# Woodfibre LNG

## Application for an Amendment to Environmental Assessment Certificate #E15-02

January 2017

Figure 2-1 Air Cooler Assembly Diagram 1

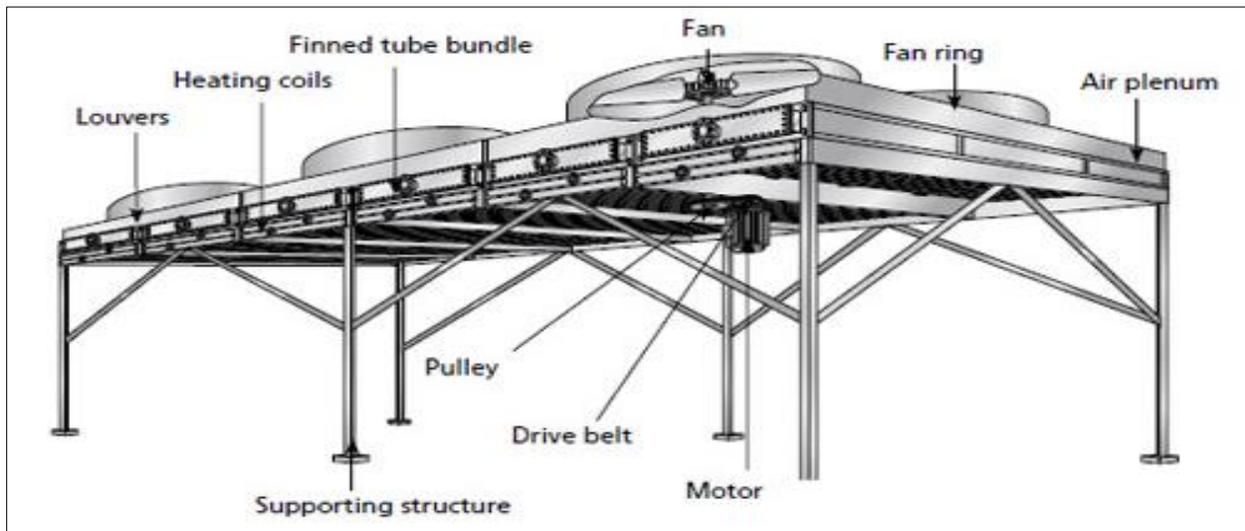
The LNG facility will be air cooled using fin fan coolers. This cooling method uses coolers with tubes containing the liquid to be cooled. These tubes have fins to increase the heat transfer surface area. Fans force air over the finned tubes and the air provides cooling by carrying heat away from the fins and tubes. The finned tubes are closely packed in a tube bundle to optimize the cooling, based on the air flow. The coolers are arranged in banks, which include tube bundles and fans in a cooler assembly mounted on top of the LNG process structure. Representations of the type of air fin cooler system that will be used for the Project are shown in **Figure 2-1** and **Figure 2-2**. The configuration of the air fin cooler system will be determined through FEED.

**Figure 2-3 Heat Transfer from Air Cooling**

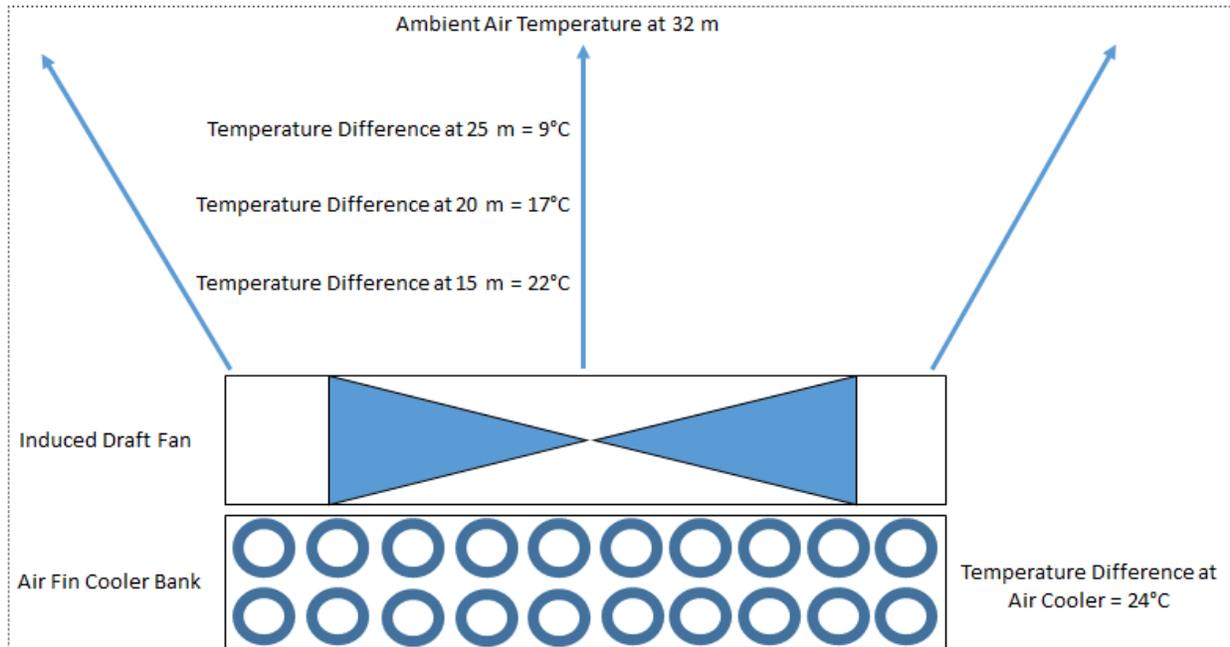
The air temperature above the air coolers is dependent on a number of factors, including wind speed, wind direction, and operating load; however, under typical conditions, the air from the fans would equal the ambient air temperature within 32 metres (m) of the system considering an 11°C ambient air temperature (as shown in **Figure 2-3**). The temperature gradient shown in **Figure 2-3** assumes that the air is directed straight upwards (i.e., no wind). Mixing associated with wind would reduce the distance that it takes the air to reach ambient temperature.

Figure 2-4	27/01/2017
------------	------------

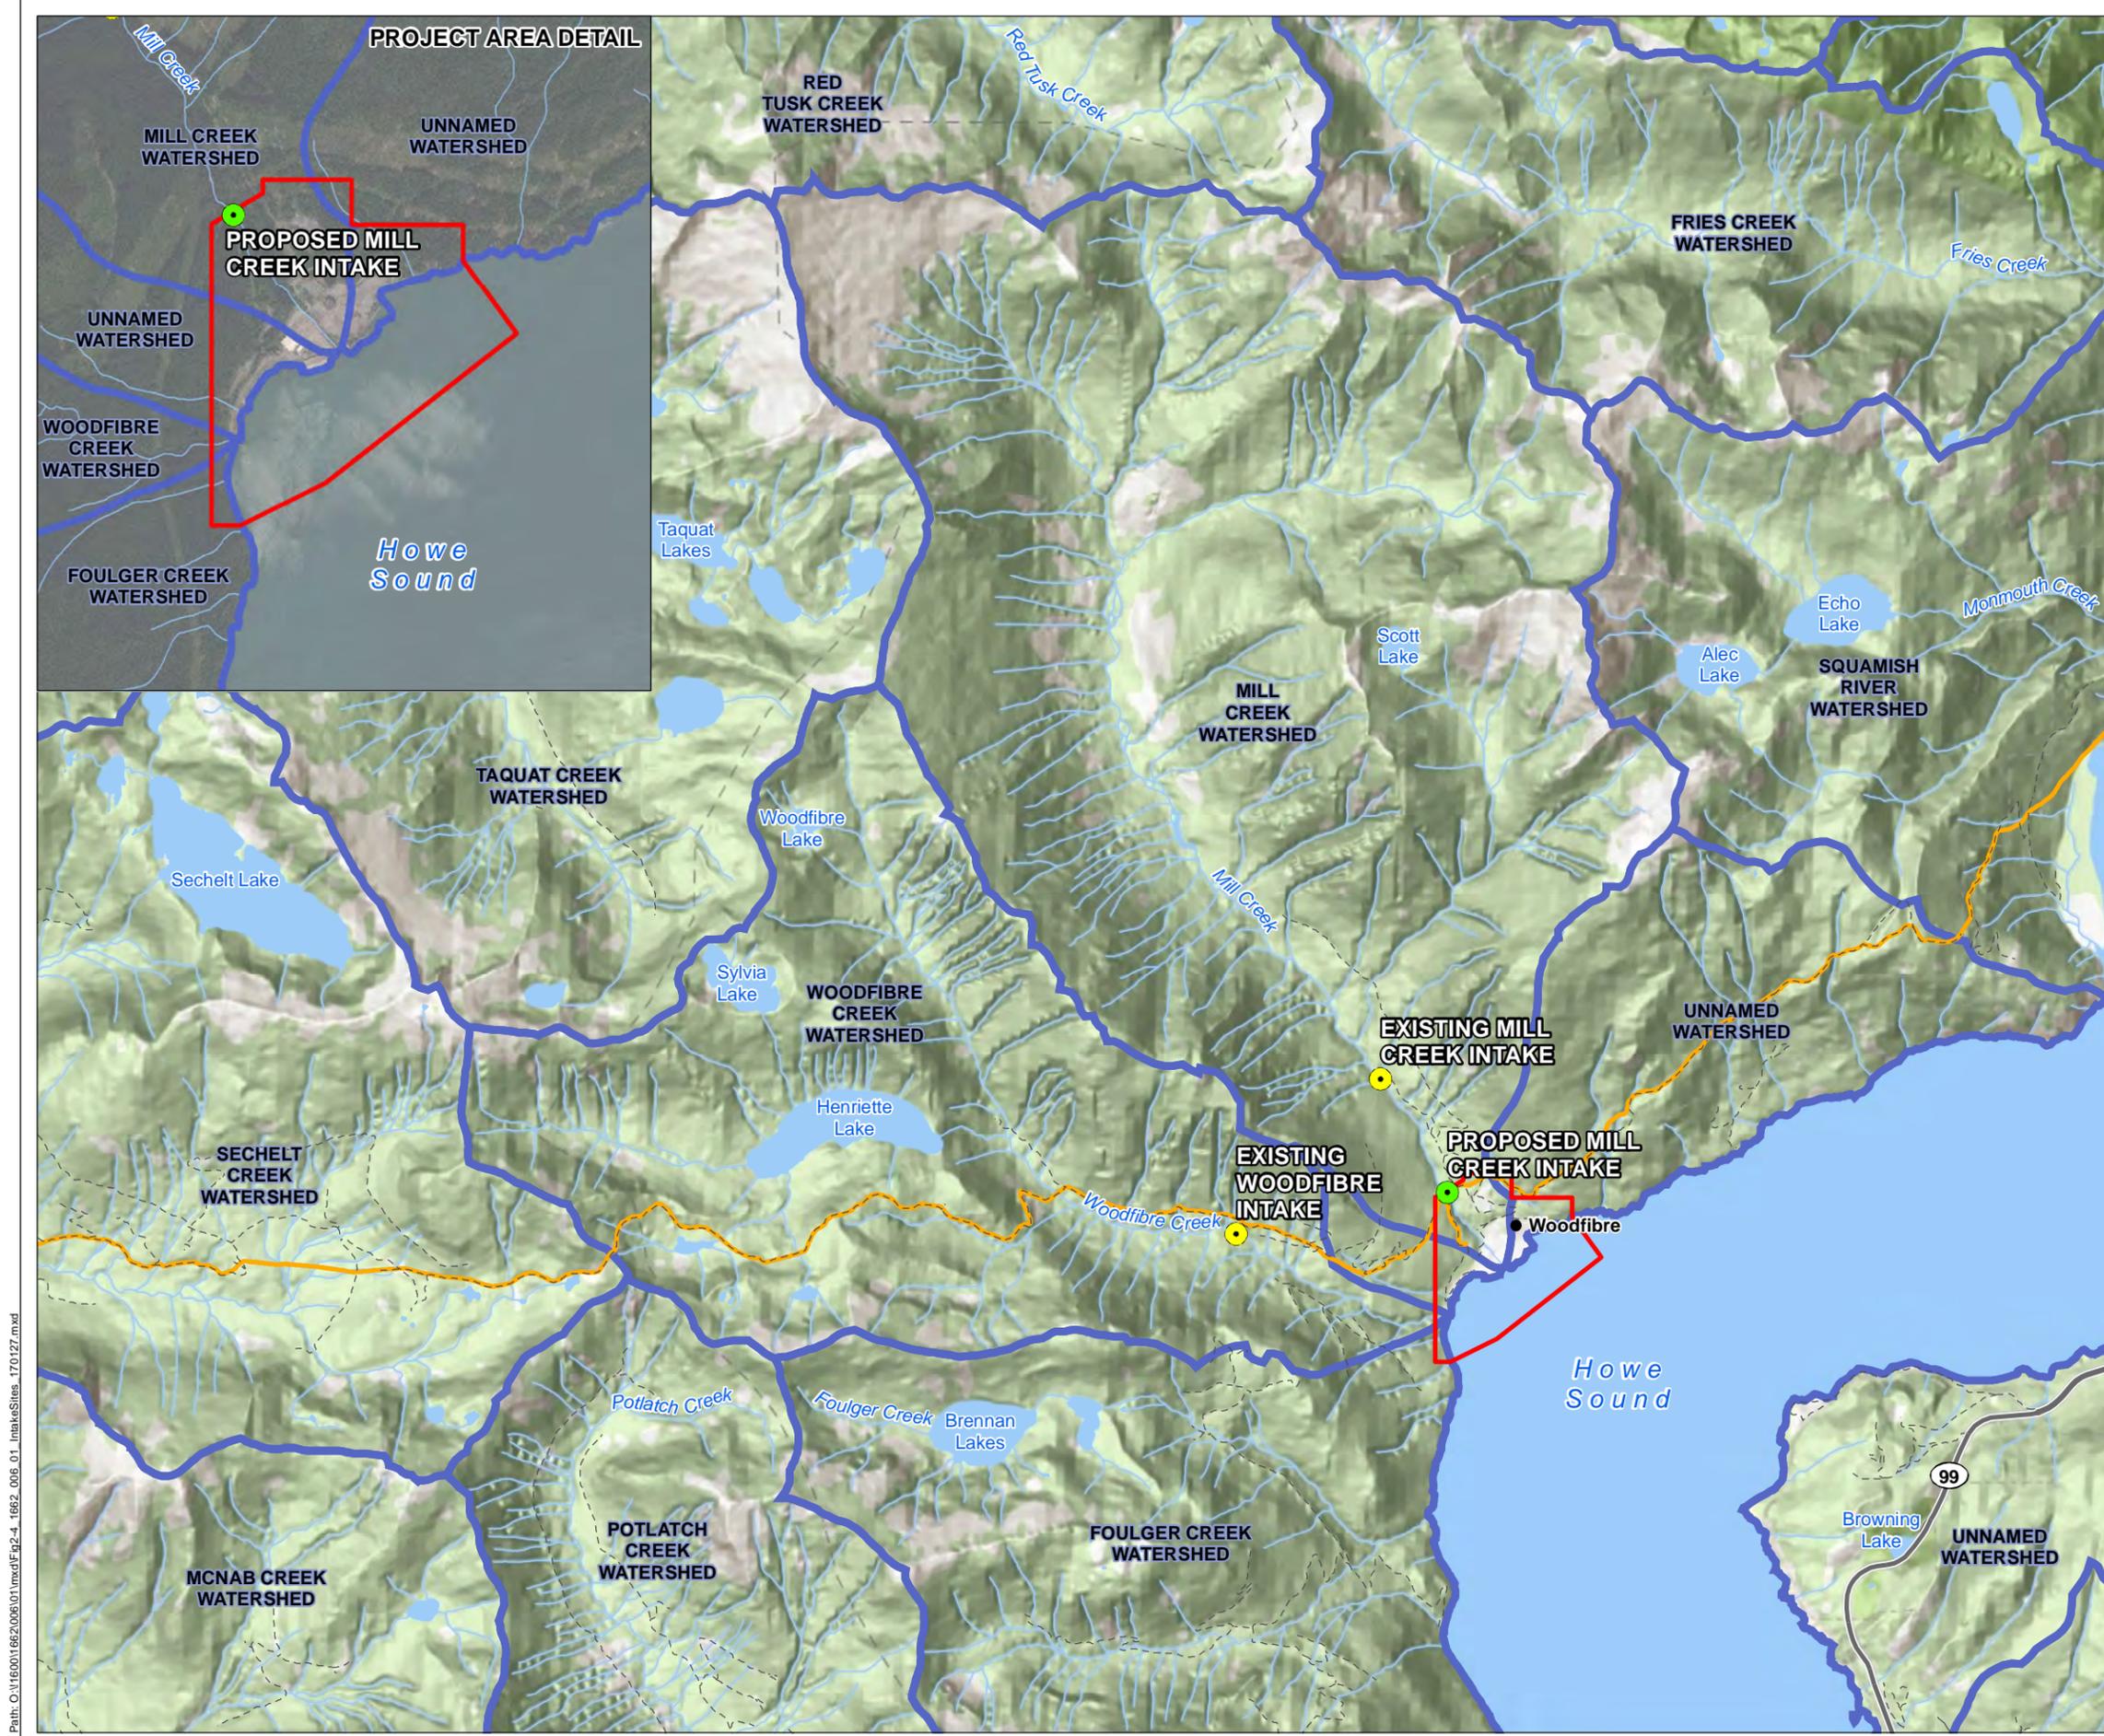
The construction and use of a new water intake on Mill Creek, located approximately 1 kilometre (km) upstream of Howe Sound, is included in the EAC. Water from the new water intake was to be conveyed via buried pipe to the fire water and raw water tank. Woodfibre LNG is currently investigating the feasibility of using the existing Mill Creek intake as an alternative to constructing a new intake. The existing Mill Creek intake site is located approximately 1 km upstream of the site proposed in the Application, approximately 2 km upstream of Howe Sound (**Figure 2-4**), and is covered by a Permit over Crown Land (No. 17347) under the provincial *Water Sustainability Act*, SBC 2014, c. 15.

The existing intake is likely to require upgrades prior to use; these required upgrades will be determined as part of ongoing investigations. If upgrading the existing intake is not feasible, a new intake may be constructed at the same location as the existing intake or remain in the location proposed in the Application. Regardless of the intake location, water will be diverted into a pipe and stored in a raw water tank located within the Project area before being used as part of Project construction and operation.

Figure 6-1	26/01/2017
------------	------------

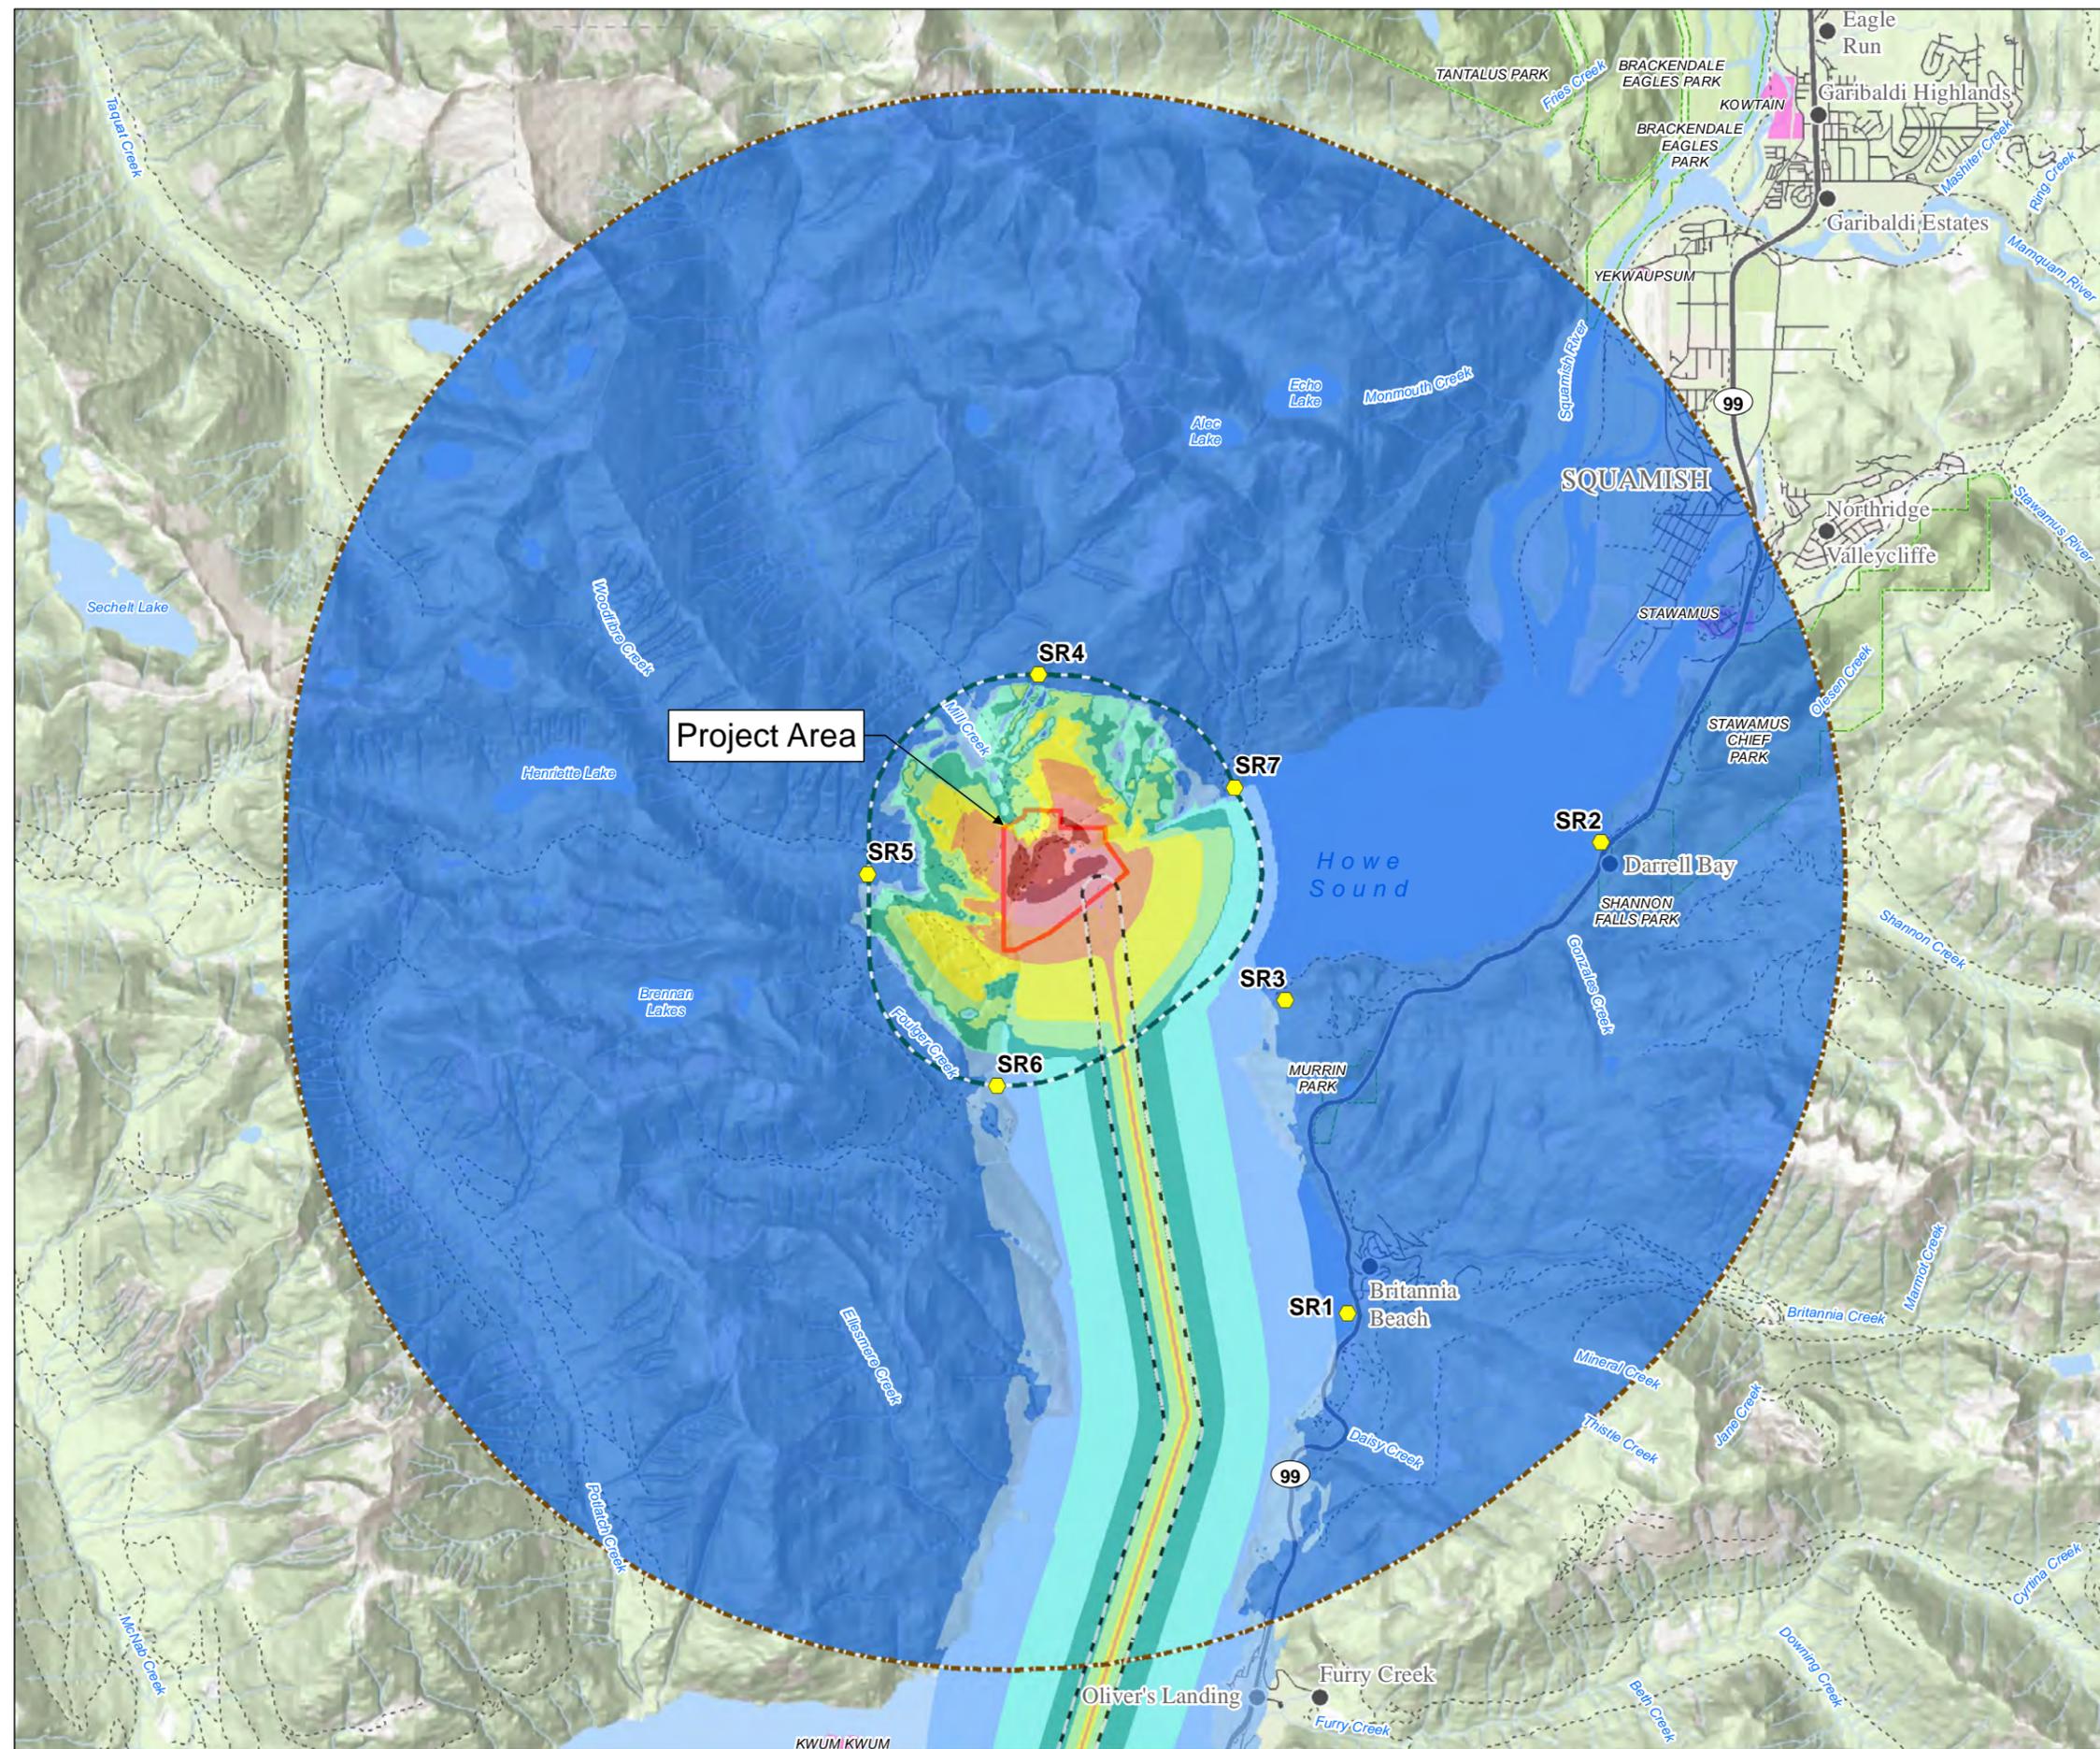
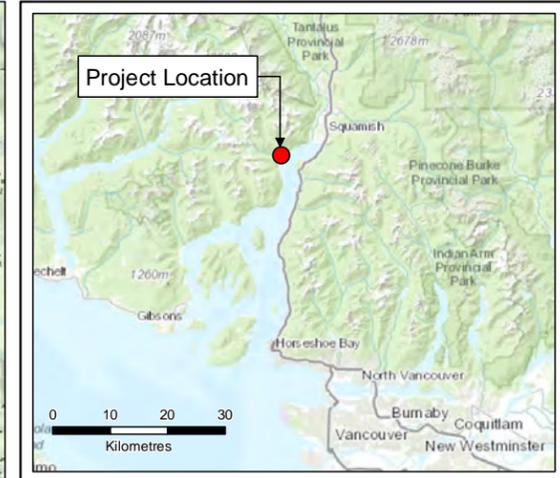
Results from the Application-case Woodfibre LNG Project with air cooling noise modeling indicate that air cooling will not perceptibly change the noise levels at the sound receptors from the baseline case, and that noise levels will remain below the OGC guidelines. Detailed modeling conducted in support of the Application calculated that the sound levels emitted by the Project as a whole are approximately 55 dBA to 60 dBA at the shoreline of the Project area, but would still be well within the OGC guidelines (2009), and aligned with Health Canada guidance (2010). The revised noise modeling results also calculate that sound levels emitted by the Project as a whole are approximately 50 dBA to 60 dBA at the shoreline of the Project area. By comparison, sound levels emitted by the Project as a whole, approximately 50 dBA to 60 dBA at the shoreline of the Project area, are equivalent to what a person would hear from a normal conversation when standing 1 m away (**Table 6-2**). **Figure 6-1** presents contours representing the Project sound levels across the LAA and RAA for the operation phase. Sound levels at SR1, SR2 and SR3 will range between 50 dBA to 53 dBA during the day and 40.1 dBA to 43.1 dBA during the night. By comparison, 40 dBA is equivalent to a sound level inside a quiet living room (**Table 6-2**).

Based on the noise modeling, the predicted changes in sound are below guidelines and within the range assessed in the Application; therefore, additional mitigation measures are not required and the assessment of the residual changes inclusive of the air cooling system do not change from those in the Application.
